Bulletin No.: PIC6026

Service Bulletin

Subject: Unable To Connect High Voltage Cable To Replacement Accessory DC Power Control Module (APM)

Models: 2011-2013 Chevrolet Volt

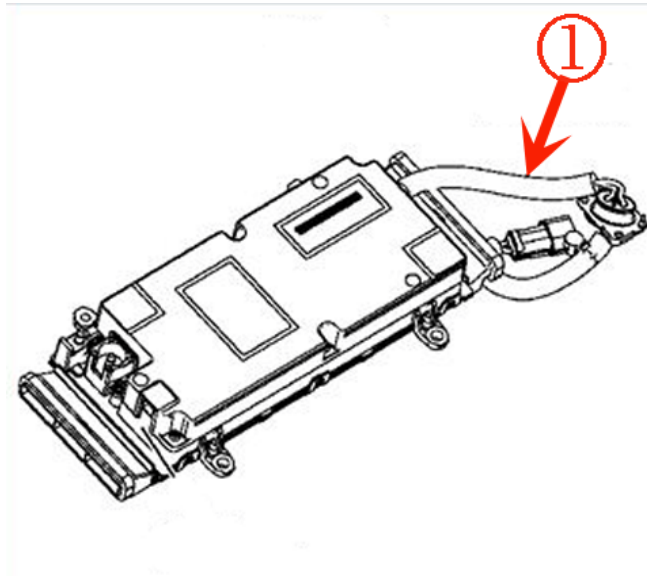
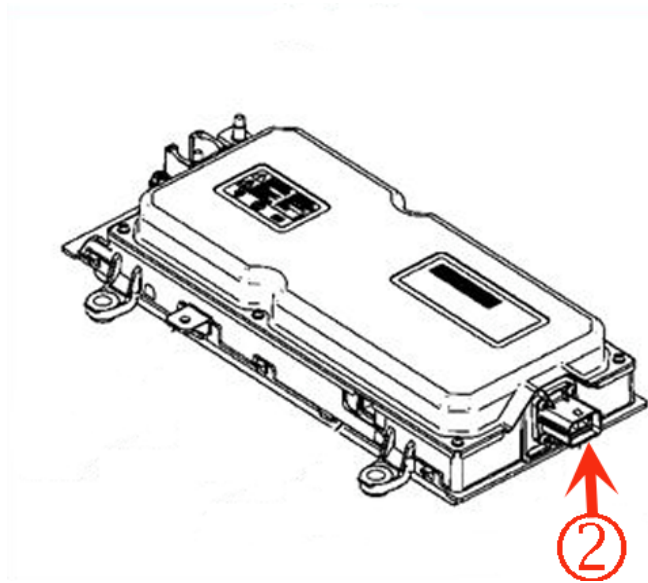
Certain 2011-2013 Chevrolet Volts were equipped with a first design APM which has a 24 inch orange pigtail attached to the module and there is no high voltage connection right at the module itself (See Photo Below)

When replacing the APM with a new service part APM, you will notice that the new part has no pigtail and the high voltage connection is right at the module itself (See Photo Below)

If your vehicle has a first design module and you are replacing the APM , an additional jumper harness (GM Part Number 24268507) will need to be installed. An instruction sheet will be provided with the jumper harness kit on how to install the new design module. If the jumper harness instructions were not included with the new part, please contact the Technical Assistance Center for a copy of the instruction sheet.
